Service Advisory

CC-661

LTX1000 SERIES

Subject: **42" and 46" Decks' RH Idler Binding**

FIGURE 1

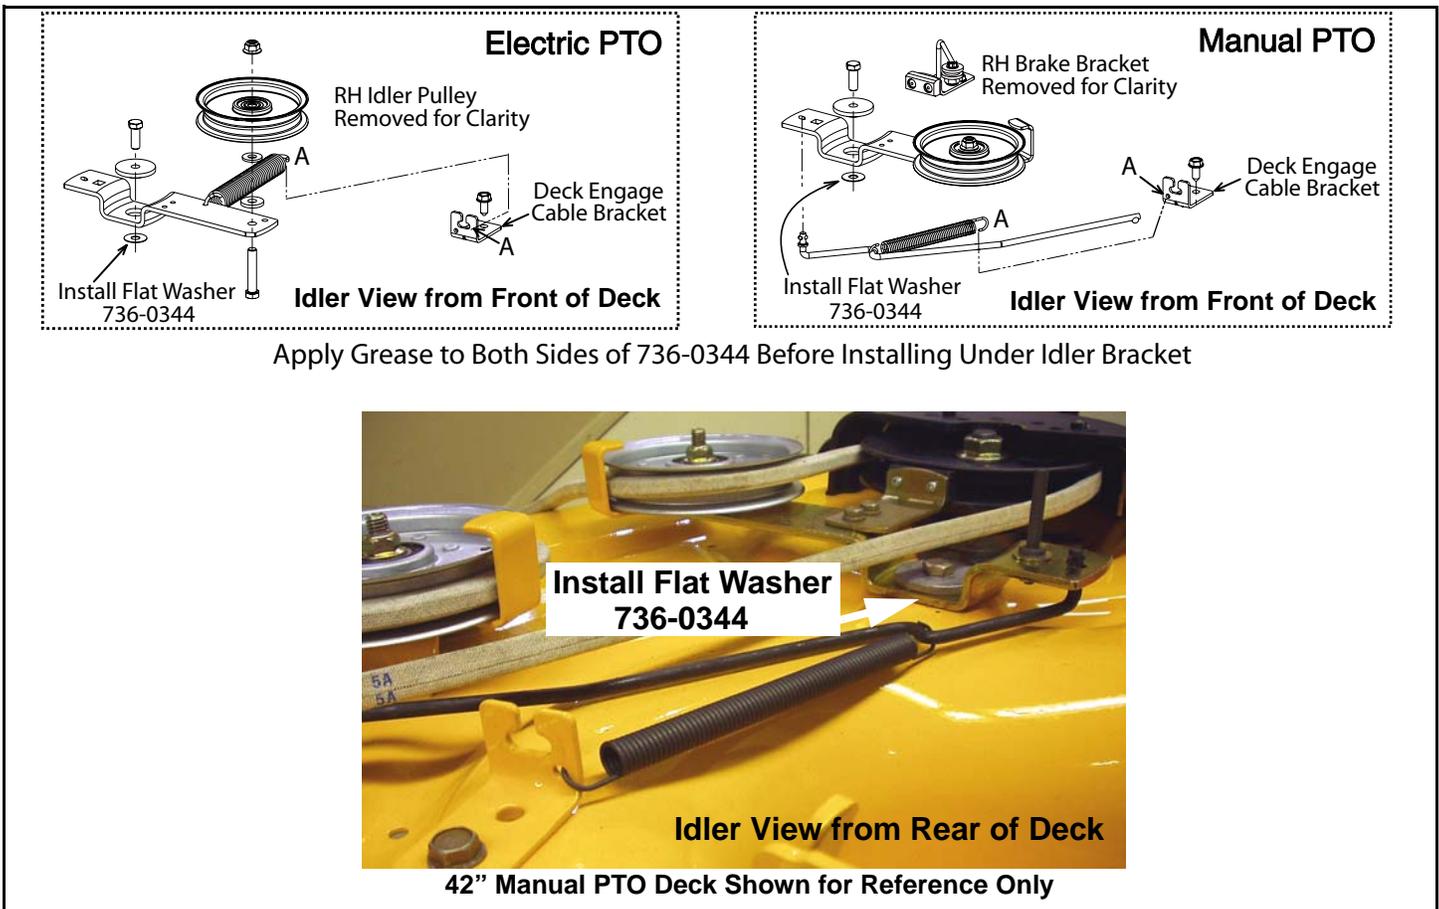
PURPOSE: Heavy debris build-up on the deck may cause the right hand idler bracket to bind resulting in degraded cutting performance.

PARTS REQUIRED: Qty. (1) = 736-0344 - Flat Washer: .385 I.D. x 1.0 O.D. x .030"

3. Allow engine and muffler to cool before proceeding.
4. To facilitate access to the RH tensioning idler remove deck from under the tractor.
5. Install a spacer washer in accordance with Figure 1.
